IDAP REPORT

Property:	14 Myee Avenue Strathfield DA2021/303
Proposal:	Demolition of existing structures and construction of a two storey dwelling with basement, in-ground swimming pool and landscaping.
Applicant:	G Al Ali
Owner:	D Azzi
Date of lodgement:	6 December 2021
Notification period:	13 December 2021 to 17 January 2022
Submissions received:	Nil
Assessment officer:	L Gibson
Estimated cost of works:	\$988,900.00
Zoning:	R2-Low Density Residential - SLEP 2012
Heritage:	No
Flood affected:	Yes
Is a Clause 4.6 Variation Proposed:	No
RECOMMENDATION OF OFFICER:	APPROVAL

Figure 15: Original ground floor plan showing proposed driveway design and its proximity to street tree.

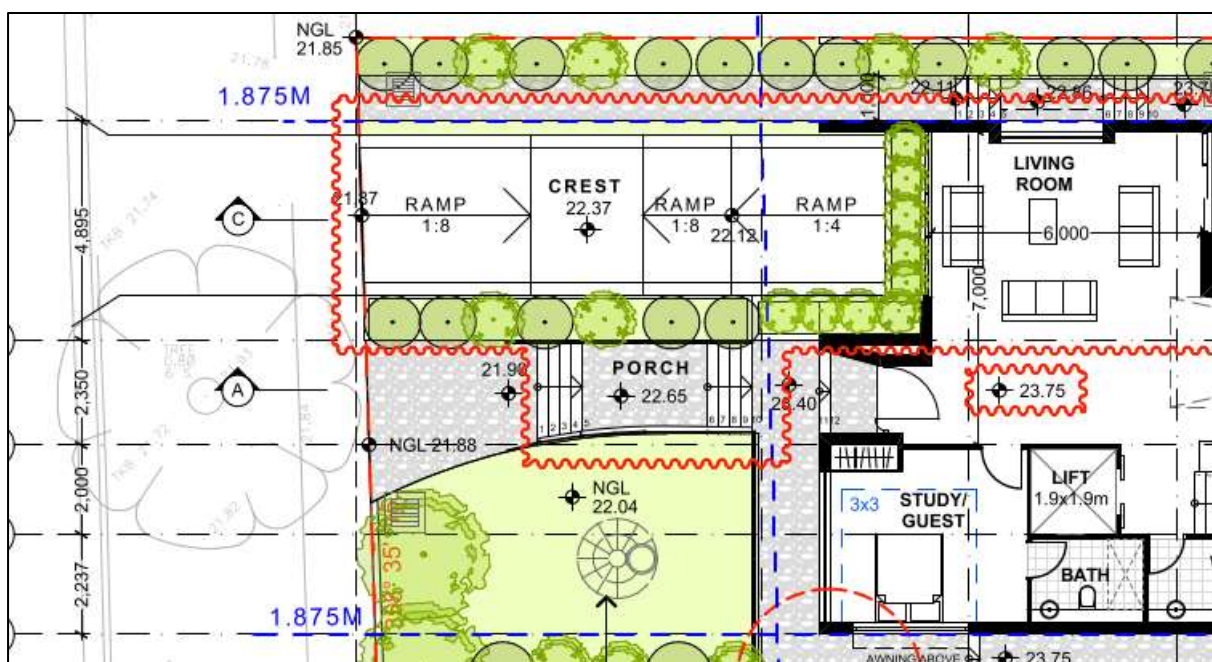
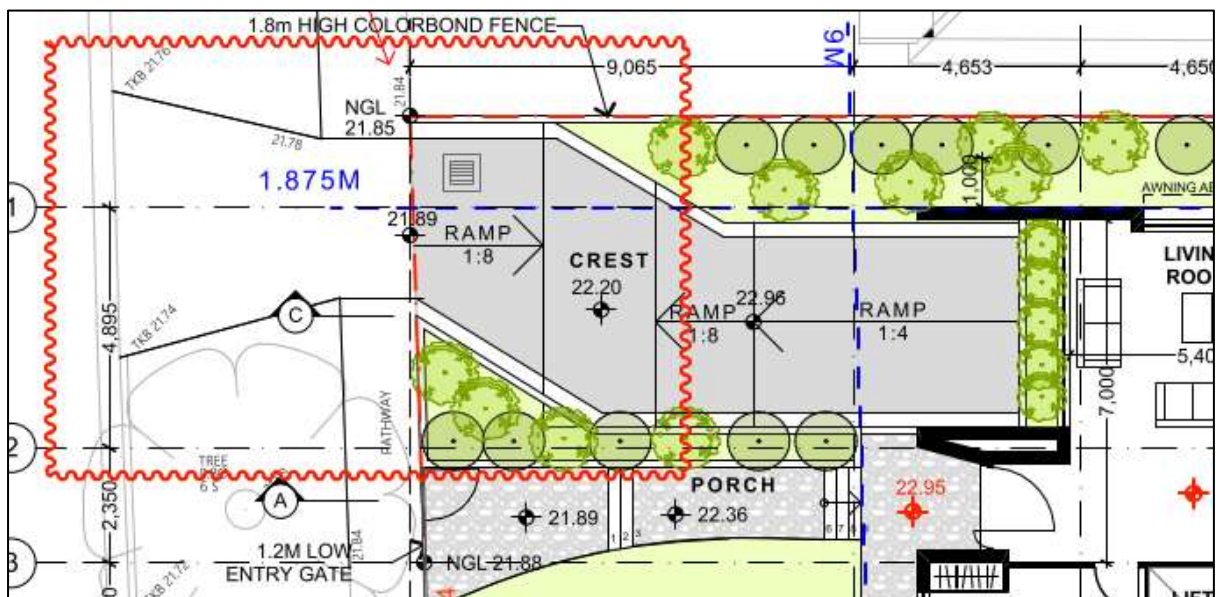
The application was referred to Council's Tree Officer for comment. Concern was raised with the close proximity of the driveway and swimming pool structures to existing trees including the Council street tree (refer to original plans in Figures 15 and 16 below). These matters were also raised in the submitted consultant's Arborist Report.

a nil setback to the northern boundary as well as an angled driveway which fails to directly align with the basement entrance. A driveway entrance that more closely aligns with the basement entrance is a more suitable and safer option as it allows for a more direct line of sight to be provided for vehicles.

Council's Tree Officer has advised that the existing driveway be retained or, at minimum, that the crossover is located a minimum 2.6m off the base of the tree. Given the irregular configuration of the revised driveway, a condition of consent is recommended for the existing driveway crossover to be repositioned 800mm south of its current location so that it achieves a minimum 2.6m from the street tree. This will enable a more uniform driveway layout to be achieved which better aligns with the basement entrance and a safer path of travel for vehicles whilst also maintaining an acceptable distance from the street tree.

Amended plans were prepared and submitted during the assessment process demonstrating the retention of the existing driveway layback, relocation of the swimming pool and some deletion of associated paving in the rear yard (refer to Figures 17 and 18 below). Whilst this is generally acceptable, concern is raised for the revised driveway design. The revised proposal has sought to retain the existing driveway layback an angled driveway between the front property boundary and basement entrance is now required. This results in an irregular driveway design that is not uniform with existing driveways in the street and reduces visibility for pedestrians and vehicles.

The proposal was referred to Council's Tree Officer who raised concern for the close proximity of the development to existing trees on site including the proximity of the new driveway to the street tree. The proposal has been amended showing relocation of the swimming pool so that it immediately adjoins the rear alfresco area and maintains a suitable distance from existing trees in the east and south-eastern corner of the site. As previously mentioned, a condition of consent is recommended to reposition the driveway so that it more closely aligns with the basement entrance whilst maintaining an acceptable 2.6m distance from the street tree.

Figure 19: Original Streetscape Elevation Plan

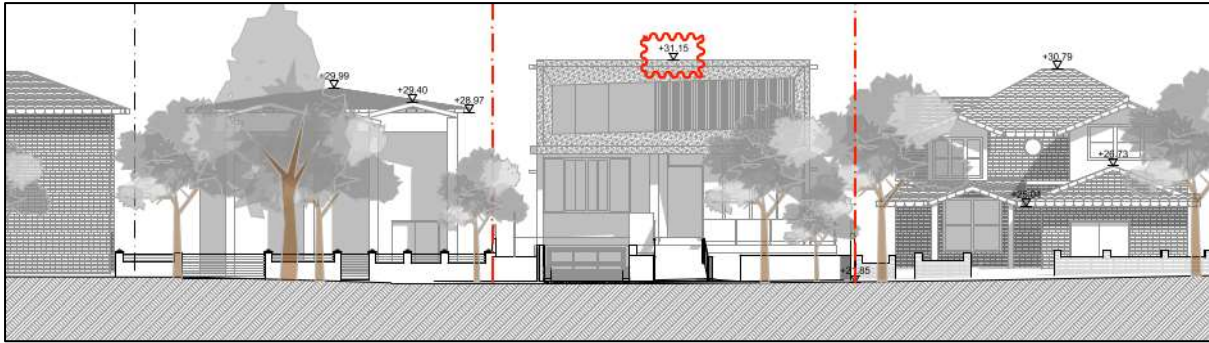
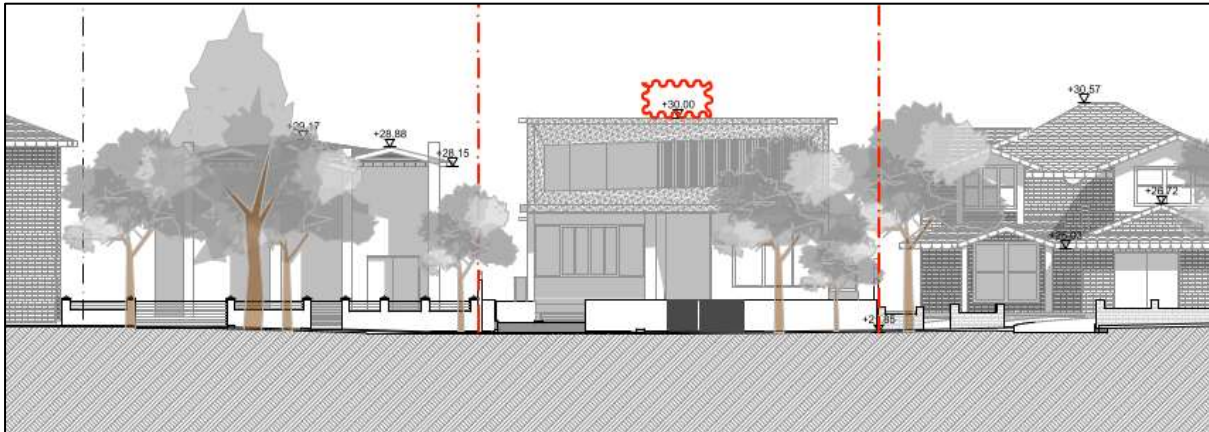
The proposal has been revised during the assessment process to achieve a reduced building height overall (refer to Figures 19 - 22 below) that better aligns with existing adjoining development. The proposal now results in a floor to ceiling height of 3.45m to the front ground floor portion of the dwelling, a 3m building height to the rear ground floor level and 3.1m to the first floor of the dwelling. The central void spaces result in a floor to ceiling height of 6.25m. These floor levels exceed the maximum permitted 3m floor to ceiling heights permitted by the SCDP 2005.

Notwithstanding the above, a condition of consent is recommended to reduce the floor to ceiling heights of the first floor (excluding void space) from 3.1m to 3m so that the entire building comply with the 7.8m building height for the site.

Figure 24: Shadow diagrams including impact of amended design

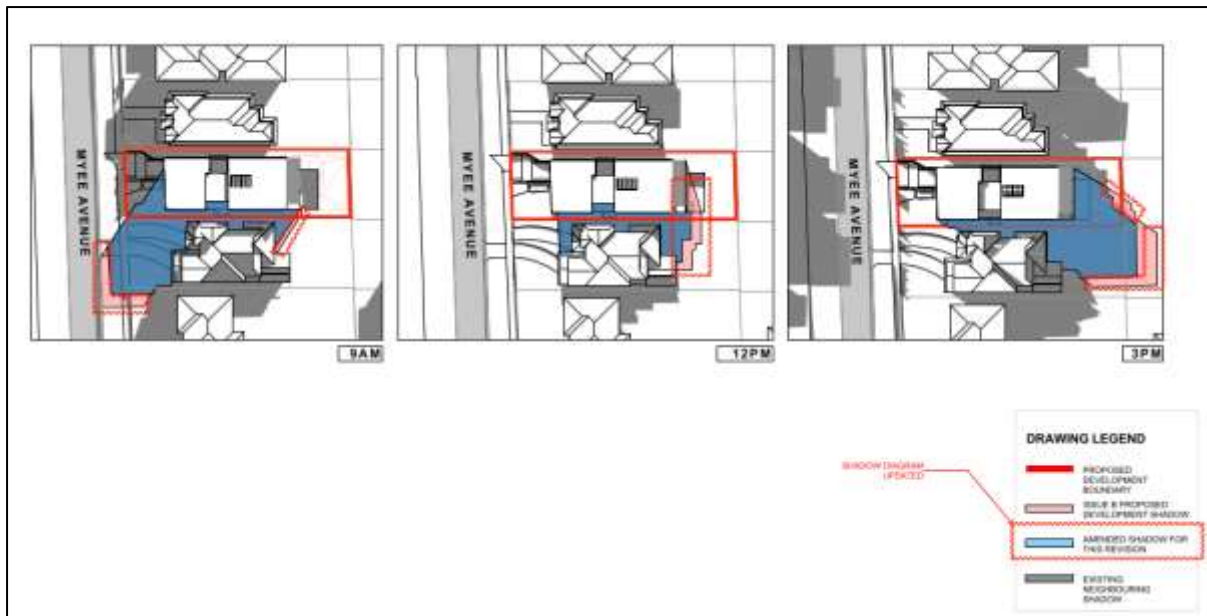
The site is provided with an east-west orientation resulting in an unavoidable degree of overshadowing to the southern adjoining dwelling and surrounding open spaces. A series of revised shadow diagrams accompanied the amended design plans to demonstrate the overshadowing impacts to the southern adjoining dwelling (refer to Figures 24 and 25 below).

The proposed amendments have resulted in a slight improvement to solar access provided to the southern adjoining property particularly to the rear property from 12pm onwards. The modelling indicates that the adjoining dwelling will receive direct sunlight to the rear yard and rear eastern rooms. From 12pm onwards, the front western rooms and front yard will receive direct solar access. It is also acknowledged that these diagrams are indicative of a worst case scenario (winter solstice) and that solar access will improve in other times of the year. Overall, the proposed development enables ample solar access to be provided to the southern adjoining dwelling through the day.
